N.E. Cor. Sec
T. 9. N. R. 2. W
(See page ½)

alignment of Mill ditch

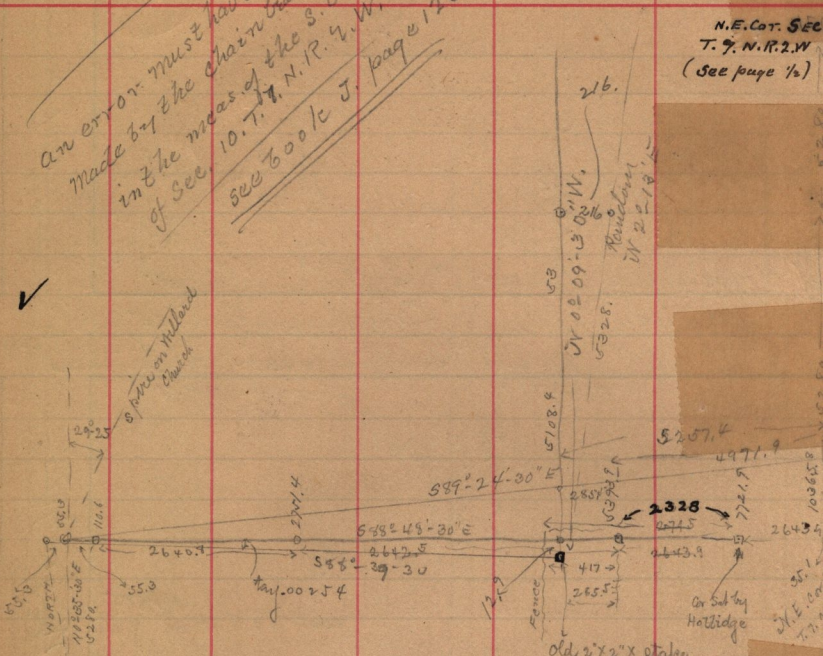
an error must have been made by the chain bearers in the meas. of the S. line of Sec. 10. T. 7. N. R. 7. W.

should remain center △ 8+57.7 Angle Right

May be swing 8 ft w. by curve △ 5+04.5 Angle left. 33°-0

swing center 6 ft to left with curve △ 3+55.33. Angle left 28°-40'

with curve.
ditch center to be swung 12 ft to left ○ 0+70 = Angle left 30°-00'
